PLANNING DEPARTMENT STAFF ANALYSIS PARK MASTER PLAN

CASE NUMBER: 2025-0016

REQUEST: Approval of a Park Master Plan for Eastchester Park per AMC 21.05.040G.2.b.i.B.

Figure 3- Master Plan Recommendations (pg. 45)

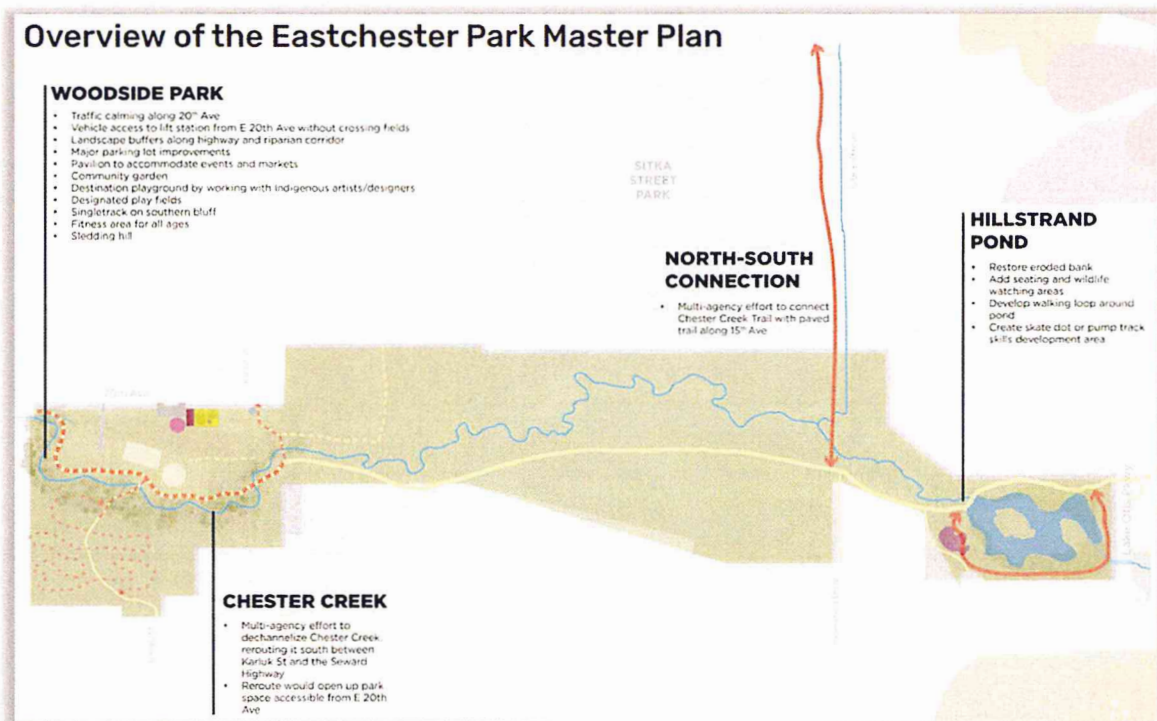
- DOT&PF will not allow any vegetation to be planted within the DOT&PF ROW along the Seward Highway.

- DOT&PF is currently conducting the Seward to Glenn PEL (Planning and Environmental Linkages), a transportation planning study, that may or may not drastically alter parkland to accommodate widening or diversion of the Seward Highway.

- Parks and Recreation need to apply for Title 23 site permit for proposed modifications to access from the right of way and proposed parking area improvements.

The restoration of Chester Creek discussed in Section 3 of the Master Plan will require a full flood analysis and the work in, and change to the floodway, will likely require FEMA Letter of Map Revision

- Advisory Comment: The realignment of Chester Creek through Woodside Park shown in the submittal would not restore the creek to its original alignment prior to the original development of the park. The project would however restore some of the natural meanders in the creek that existed prior to channelization and the development of the park, and WMS is generally supportive of this proposal.

Topography and Seismic Zone

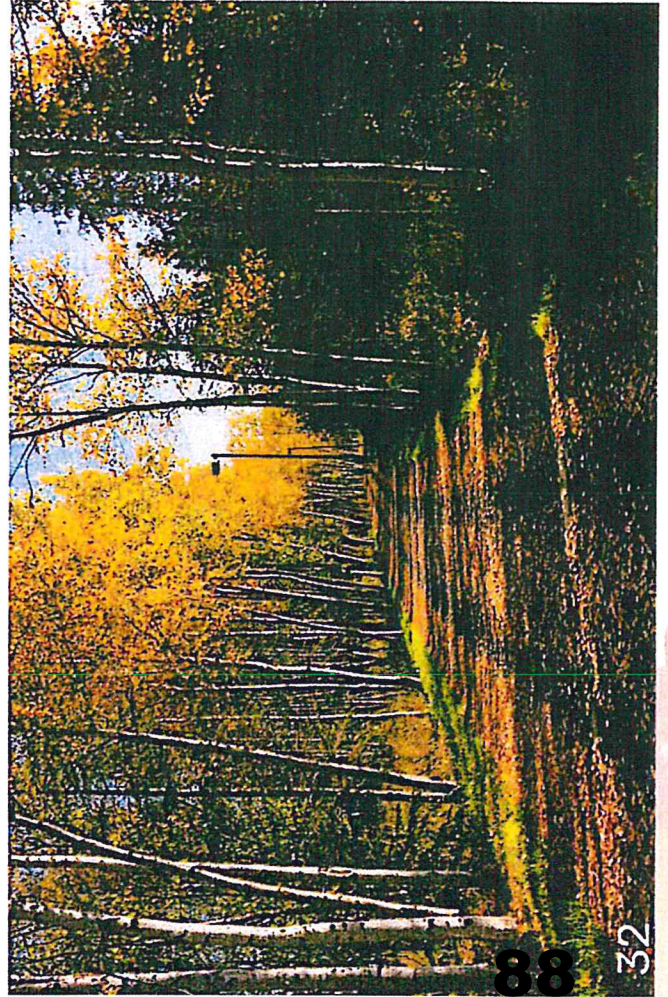
1. Update seismic zones on page 32 to show Zones 3 and 4, as depicted in the "Historic Seismically Induced Ground-Failure Susceptibility" map made available by the Municipality of Anchorage.
